Re: Proposed Plan for Ash Landfill Operable Unit
Seneca Army Depot, #850006

Re: Seneca Army Depot Activity
NYS Inactive Hazardous Waste Disposal Site No. 8-50-006
Final Proposed Plan for the Ash Landfill

Re: Proposed Plan
Ash Landfill Operable Unit
Seneca Army Depot
Site #850006
Romulus, Seneca County

**FINAL PROPOSED PLAN
FOR
THE ASH LANDFILL**

Table 9
Summary of Detailed Evaluation of Migration Control Options

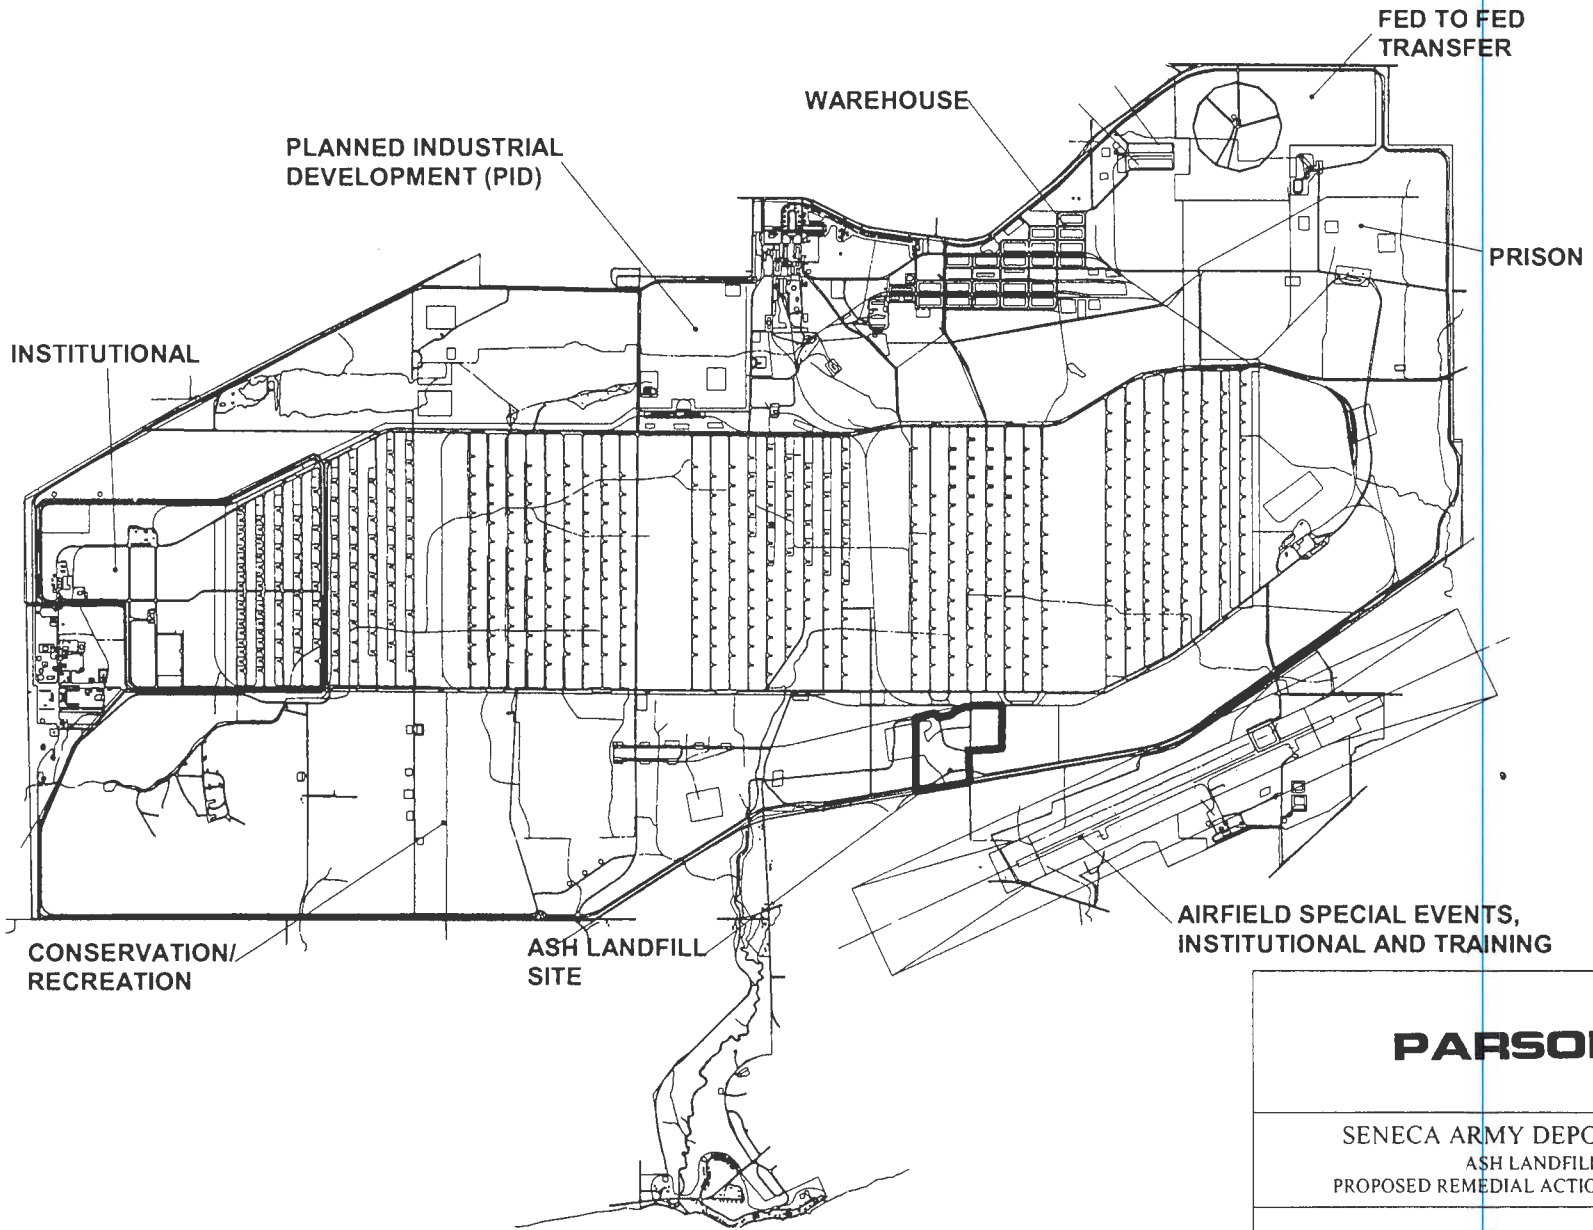
13. Table 1: Footnote 6 should be clarified further.
14. Table 9: Under Alternative MC-3/MC-3a, it states that for ability to attain approvals and coordinate with other agencies, “NYSDEC and EPA input required prior to final remedy selection.” As stated in NYSDEC TAGM #4030, “(A)dmistrative feasibility refers to compliance with applicable rules, regulations, and statutes and the ability to obtain approvals from other offices and agencies.” It is my understanding that administrative feasibility does not include the NYSDEC, USEPA or Army. This table should be revised accordingly.
